Access Compliance Report Public Rights-of-Way (Pedestrian Signals)

Main Street: ORANGEWOOD_AVE Cross Street: LOS_ALAMITOS_BLV Location: SE

ADA ID: SGRK211217115807 Signal Type: One Push Button-Non APS Overall Compliance: No Severity Scores: BTN 1: 10 BTN 2: N/A No BTN: N/A

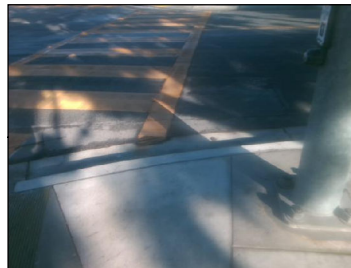
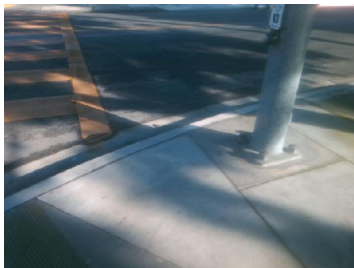
OC Std/PROW: MUTCD 4e.08

Possible Solutions: Replace Signal Push Button With APS Button.
